## DEPARTMENT OF TRANSPORTATION

### National Highway Traffic Safety Administration

#### Docket No. NHTSA-2013-0076

#### New Car Assessment Program (NCAP)

**Figure 1**

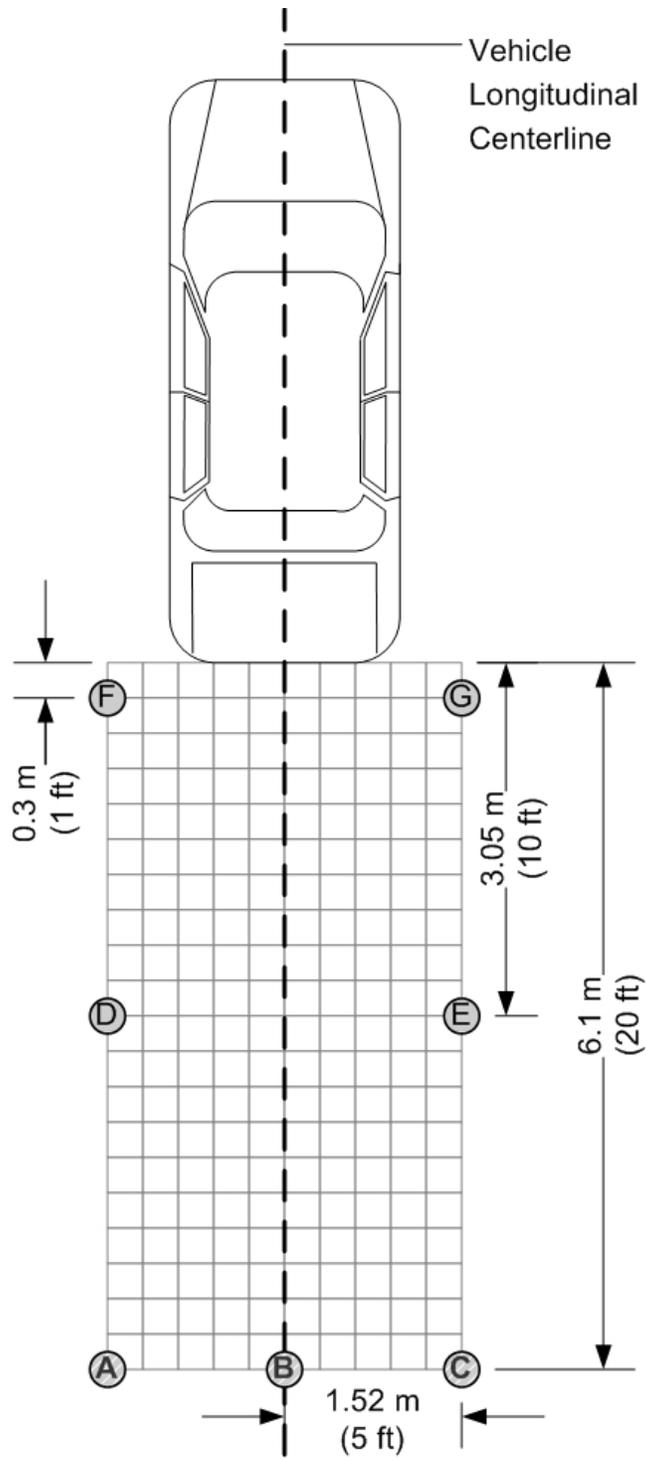
Certain manufacturers expressed two concerns with this test procedure to evaluate the field of view criterion. First, both the Alliance and Global Automakers assert that test objects F and G should be placed in a location that is proportional to the vehicle width (as opposed to 5 feet to the left and right of the vehicle centerline). They contend that vehicles using a 130 degree camera would not cover the required portions of test objects F and G (in their current locations). Second, the Alliance stated that certain vehicles with a low rear height (i.e., a vehicle that is not high off the ground) has less height flexibility for mounting a camera. Thus, the Alliance suggests that vehicles with an upper protected surface of the rearmost body structure of 750 mm or less be required to show only a minimum height of 0.4 meters (half the height) of test objects A through E (objects greater than 10 feet from the vehicle bumper).

We disagree with the manufacturers that this procedure for evaluating the field of view criterion does not accommodate vehicles with rearview video systems using a 130 degree camera or vehicles with a low rear height. When we originally developed this test procedure for the NPRM to amend FMVSS No. 111, we specifically designed this test procedure to be able to accommodate these types of vehicle designs. In response to the manufacturers' first concern, it seems clear that if we take into account three-dimensional nature of a camera's field of view, a 130 degree camera will cover the specified areas of all the test objects even if the vehicle has a low rear height. In tests conducted by the agency, the vast majority of vehicles equipped with rearview video systems were capable of meeting the field of view requirements as proposed in the NPRM.<sup>13</sup> Thus, we are unaware of any camera that has a vertical angle limitation which would prevent it from easily being mounted at a pitch which covers the full height of test objects A through E.

In response to the manufacturers' second concern, we note that the portions of the F and G test objects that must be shown are measured by width only in order to accommodate vehicles of varying height and width. Thus, we disagree with the manufacturers that a 130-degree camera is unable to cover the width parameters for test objects F and G. We believe that the diagrams presented by the commenters regarding the inability of the 130-degree camera to cover test objects F and G fail to consider the three-dimensional properties of a camera's viewing angles. As Magna, a rearview video system manufacturer, stated in their comments to the NPRM to amend FMVSS No. 111, a 130-degree camera can readily cover the 5.9-inch (150-mm) width parameters of test objects F and G when mounting height and camera pitch is considered.<sup>14</sup>
